2.206 - Watts Bar Nuclear Plant - Reactor Coolant
System Stainless Steel Cladding Defects Demand for
Information

SUBJECT: Watts Bar Nuclear Plant – Petition Pursuant to 10 CFR 2.206 – Reactor Coolant System Stainless Steel Cladding Defects Demand for Information

Looking into the cold leg piping of reactor coolant loop #2 showing defect in the stainless steel cladding at the approximate one o'clock position.

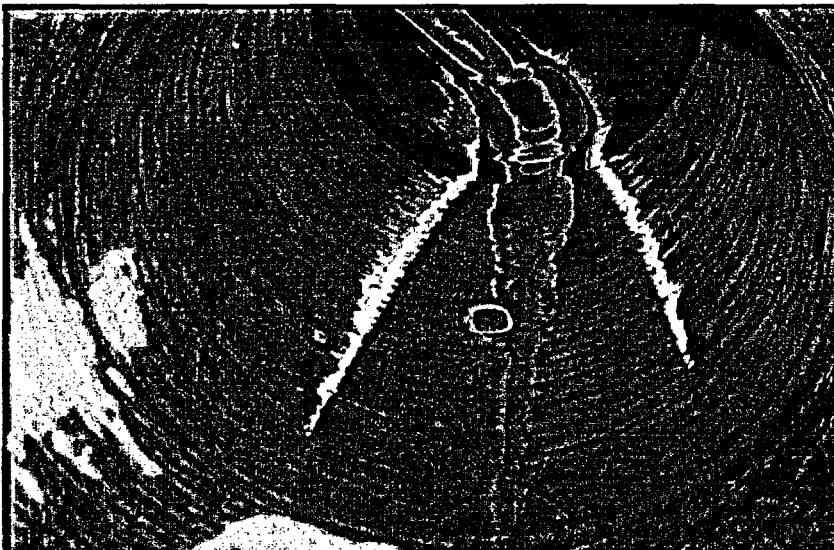
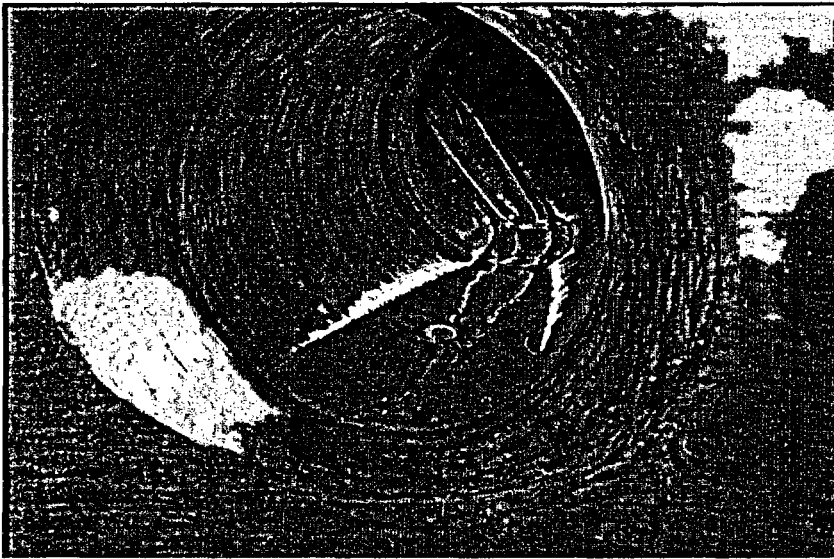
The carbon steel reactor pressure vessel at Watts Bar was coated with stainless steel to provide the corrosion resistance against the borated water used as reactor coolant. But as the photographs on the next two pages clearly illustrate, defects in the stainless steel coating for the cold leg nozzles permit direct and constant exposure of the carbon steel reactor pressure vessel to corrosive borated water.
